SERVICE TECHNICAL news

STN - WM - 0405.1 - EN

Indesit Company, Service Department

Title: **CARD/EEPROM INCOMPATIBILITY ON ELECTRONIC WMs**

**Eeprom supplier:
Fairchild
(white writing)**

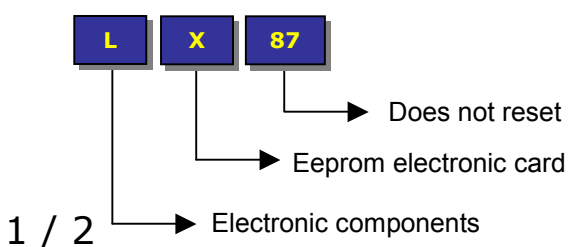
Incompatibility between the cards without the three blue capacitors (shown in the photos of the table on page 2) and the eeproms of the new "ST" supplier. In other words, the eeproms of the ST supplier require the three blue capacitors in order to operate correctly, whereas the eeproms of the previous Fairchild supplier did not.

As described in the "products concerned" section, the fault only occurs when the card or eeprom is replaced and not matched correctly (therefore check stocks in your warehouse, keeping in mind that the Fairchild supplier no longer exists).
